LiDAR Quality Assessment Report

SD_MORiver-Dewberry_2016-Block6

This task is for a high resolution data set of Geiger-Mode lidar covering approximately 8104 square miles affecting Campbell, Walworth, Potter, Sully, Stanley, Hughes, Hyde and Hand counties in South Dakota.

Vertical Accuracy Results:

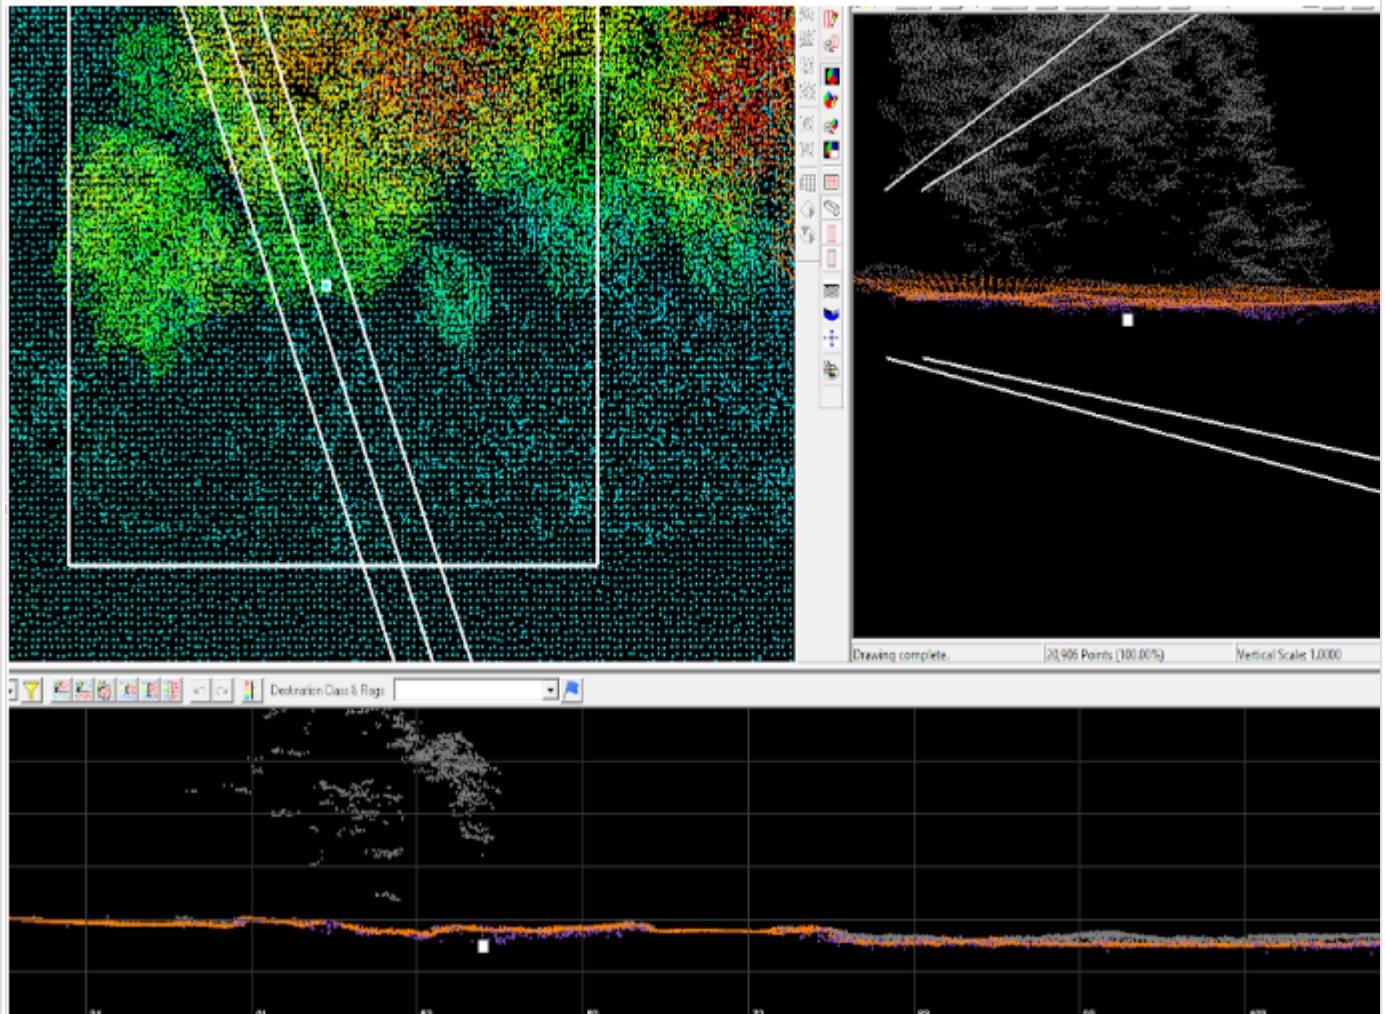
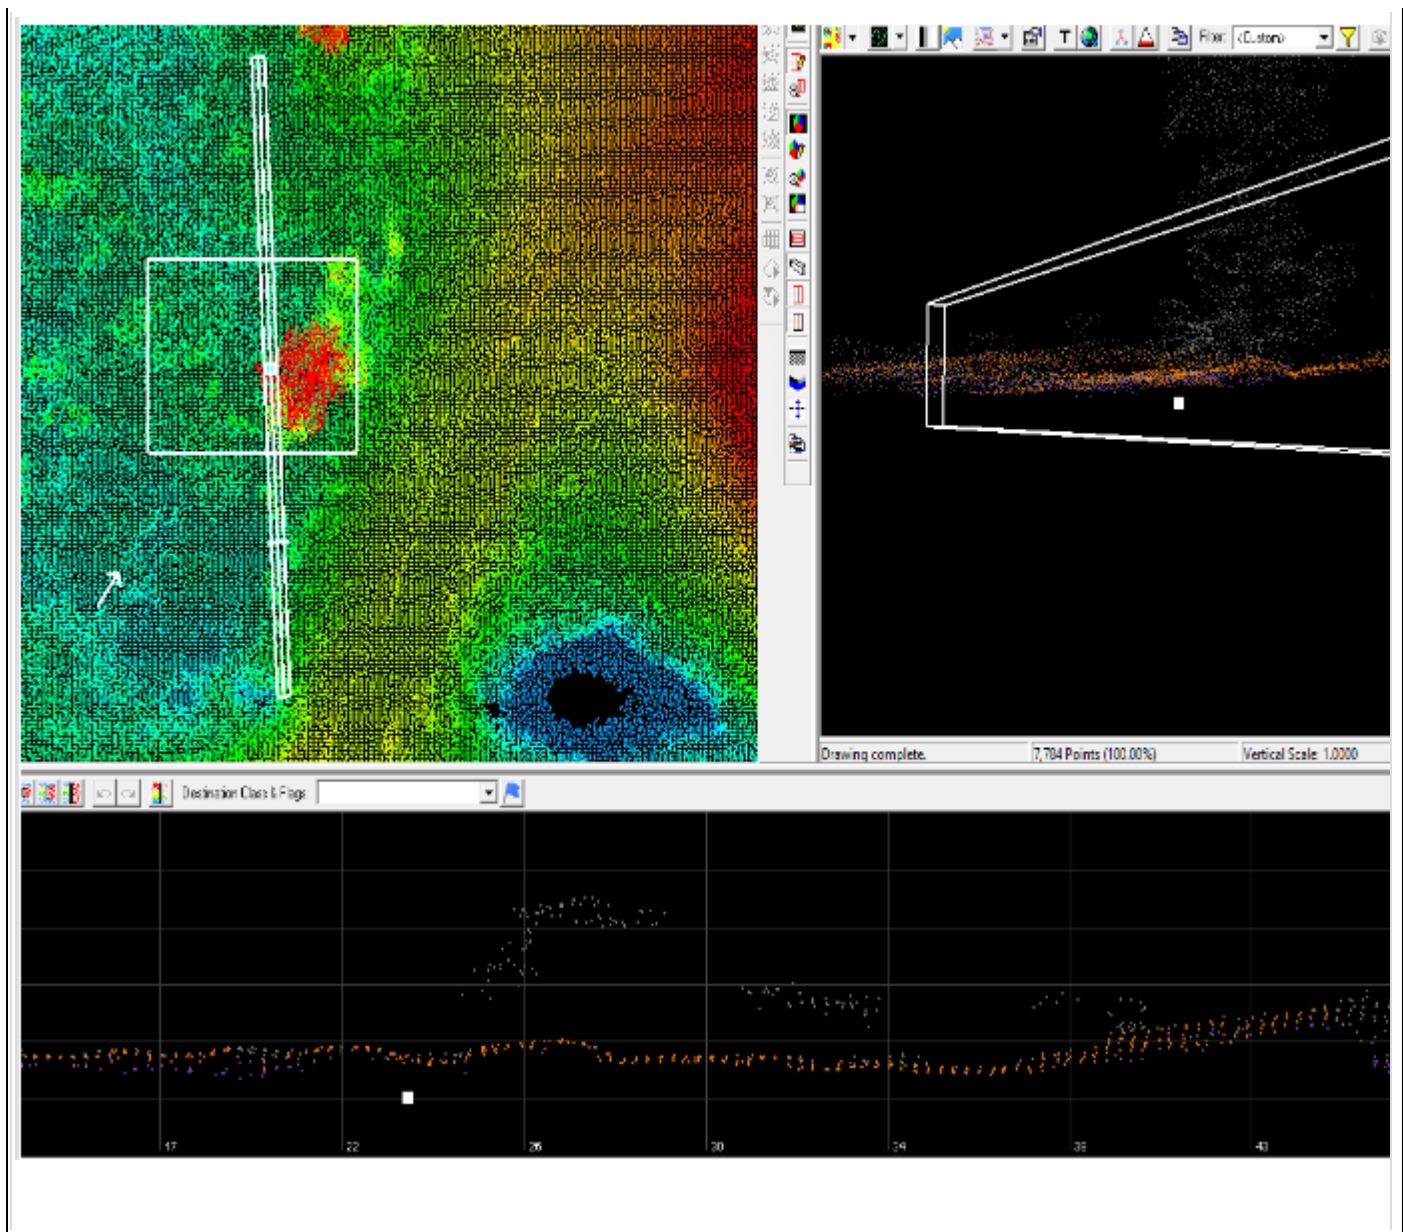
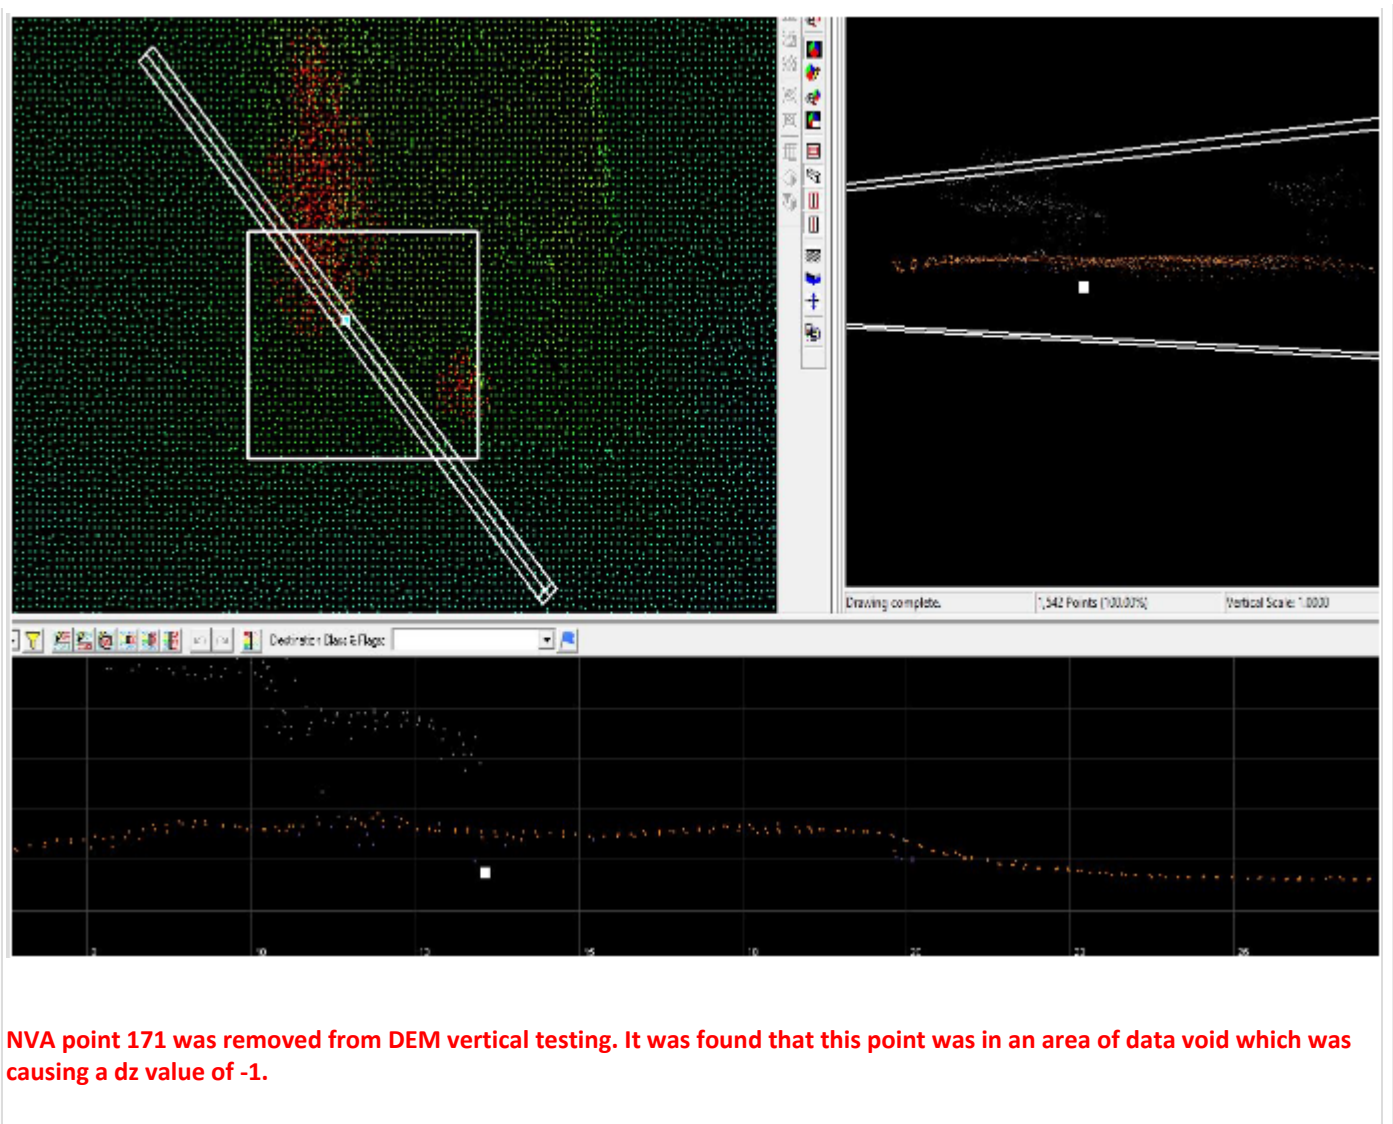
VVA testing failed to meet USGS specifications. Three of the worst points are pictured below, showing the checkpoint below the ground surface.

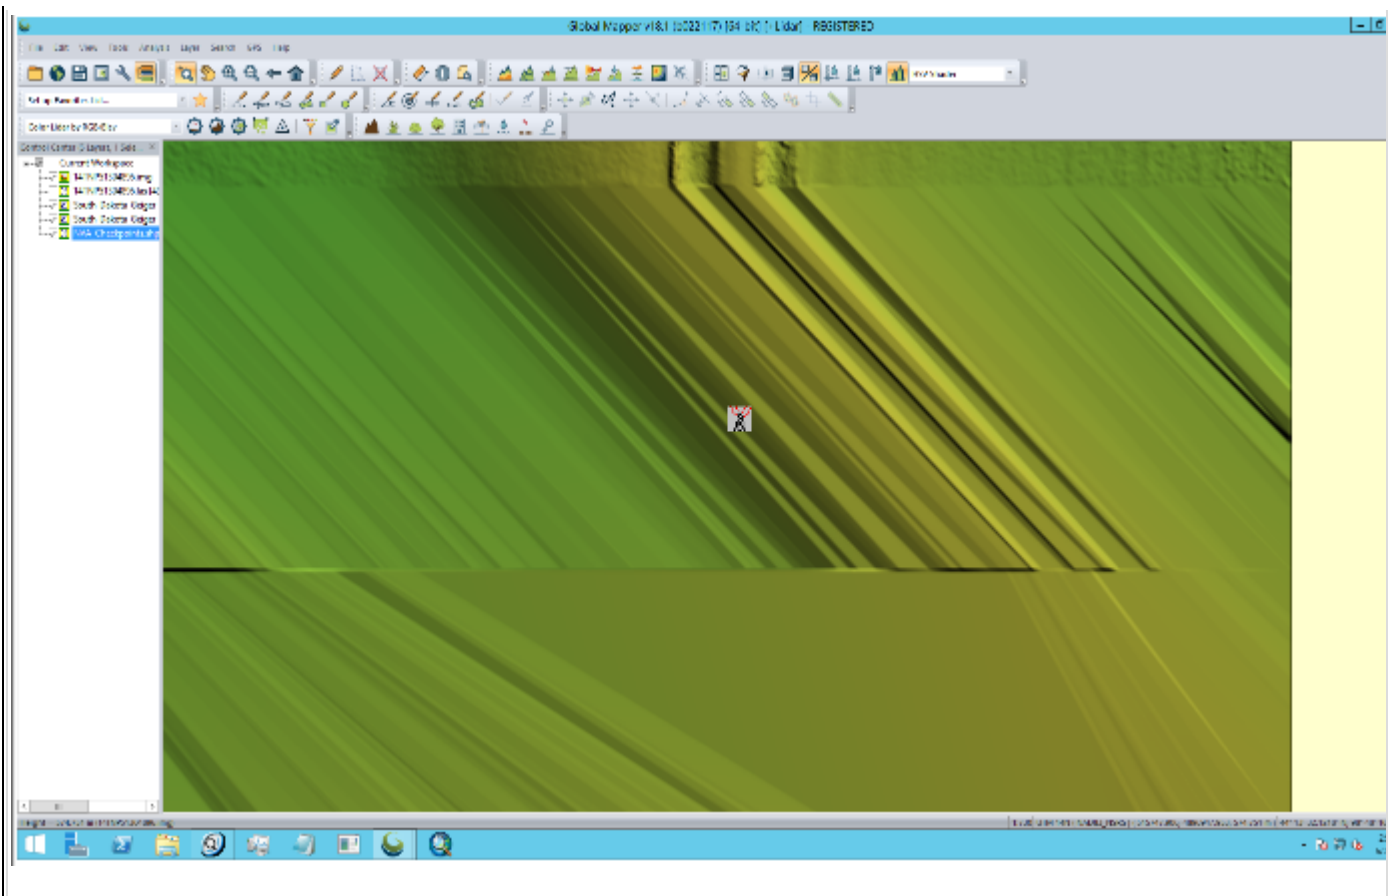
NVA point 171 was removed from DEM vertical testing. It was found that this point was in an area of data void which was causing a dz value of -1.

Between tiles 14TMQ42904952 and 14TMQ42904954:

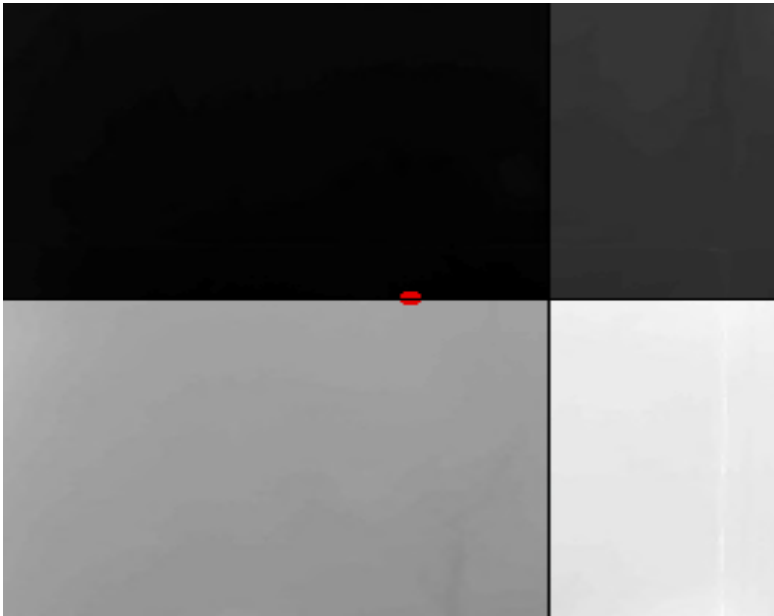
Using the footprint and dissolve tool in ArcGIS, the following gaps were found: **CORRECTED 9/2018**

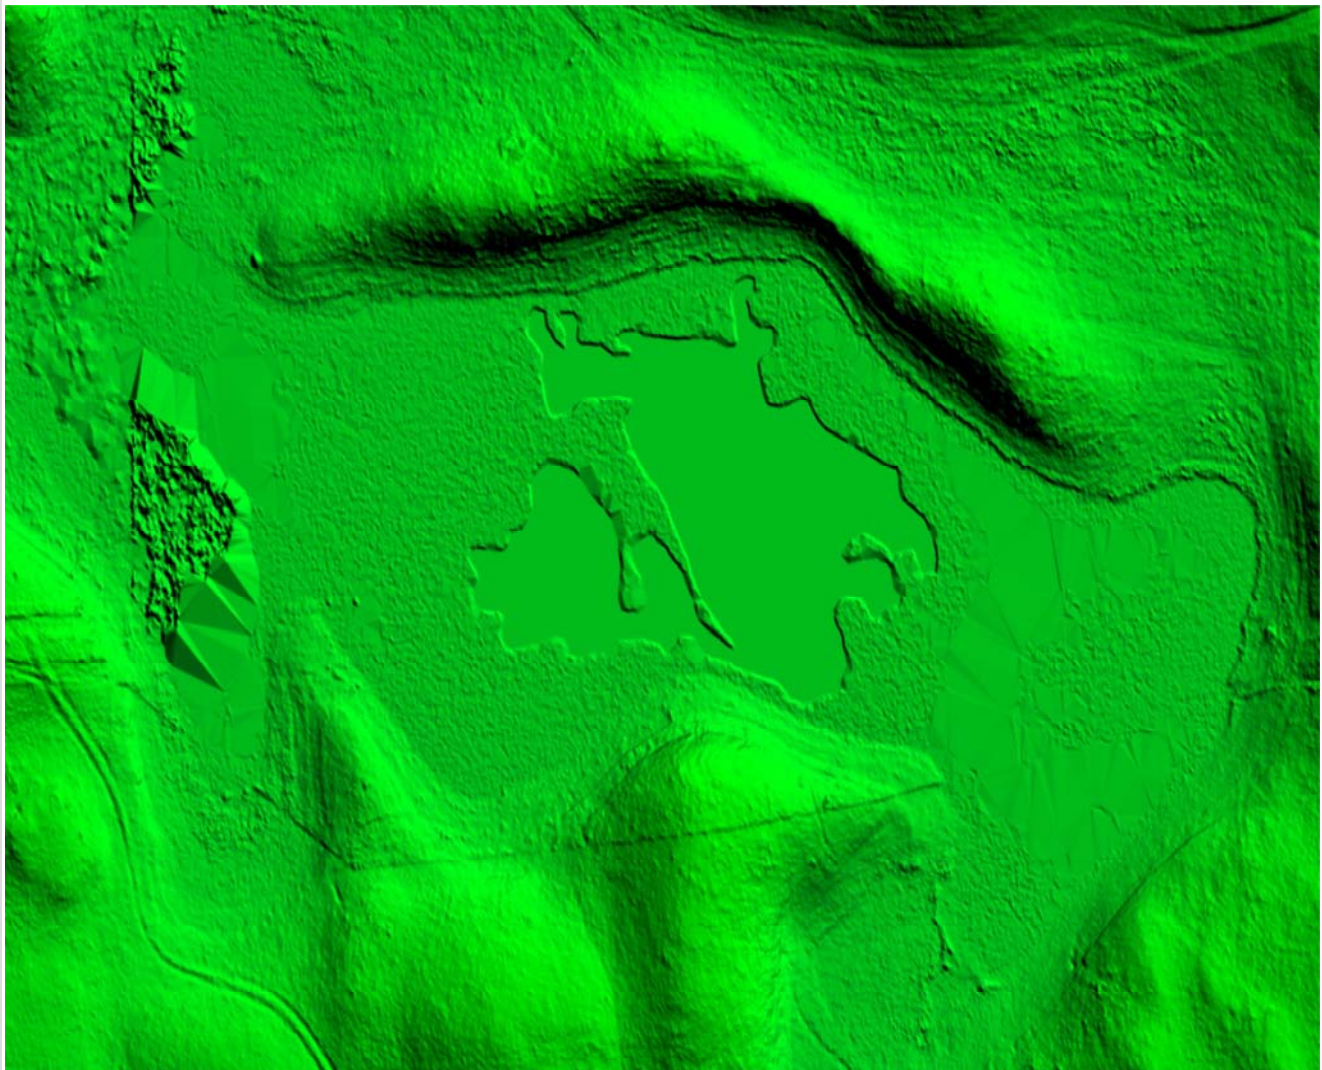
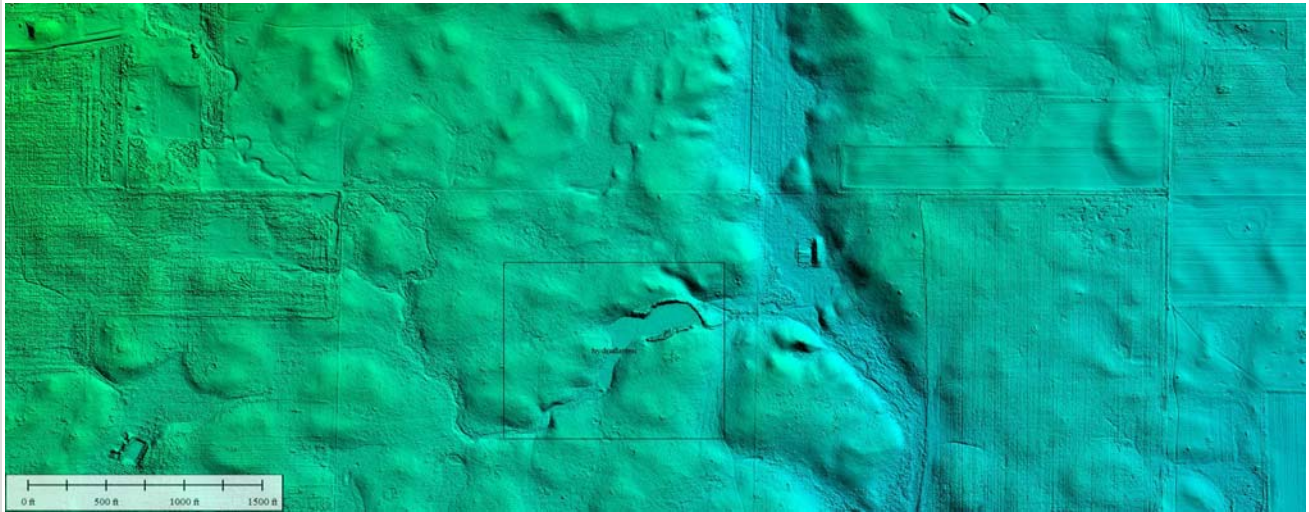
There are many more "no data" areas through out the block found by zooming into the footprint shapefile. See shapefile in error folder. Corrected 9/18/18

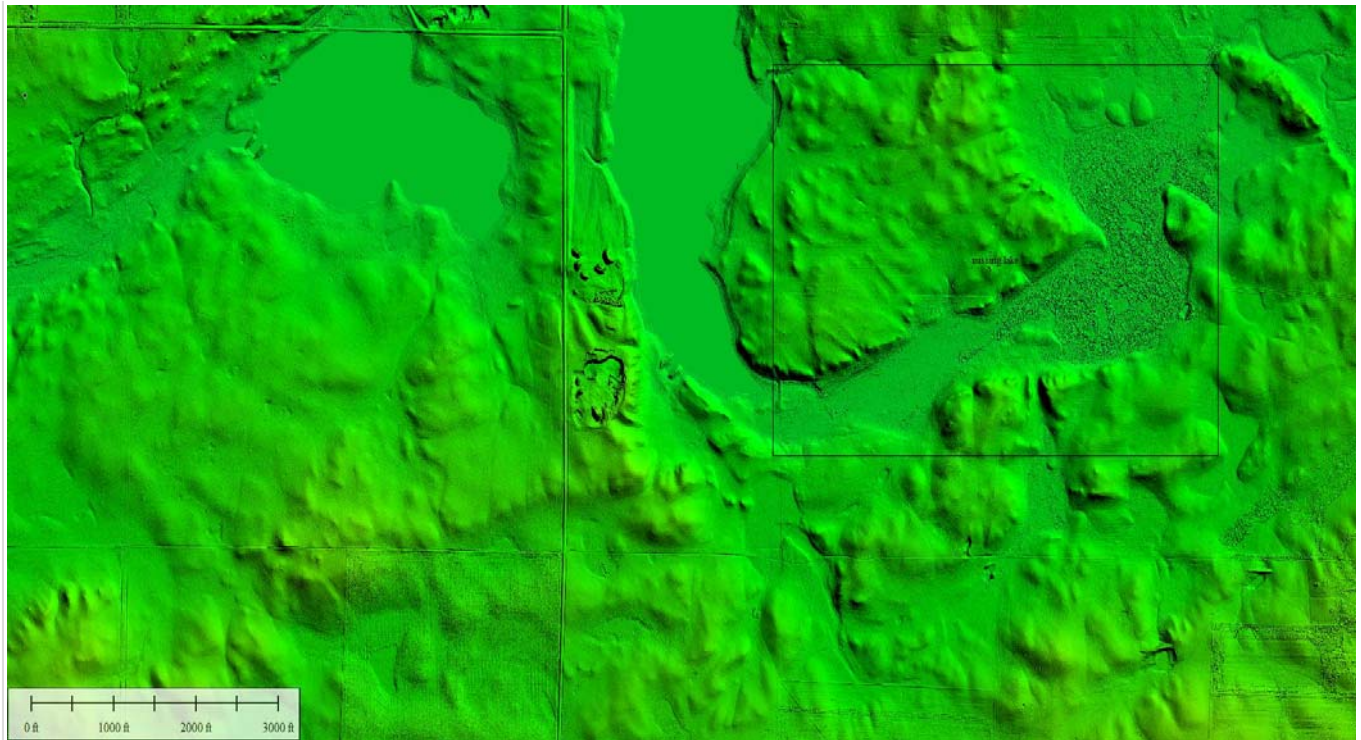
There are several ponds/lakes that were classified as ground in full or partially, and a few water bodies need to be hydroflattened. See error shapefile for examples found. There are possible more that were not found during DEM review. Corrected 9/18/18
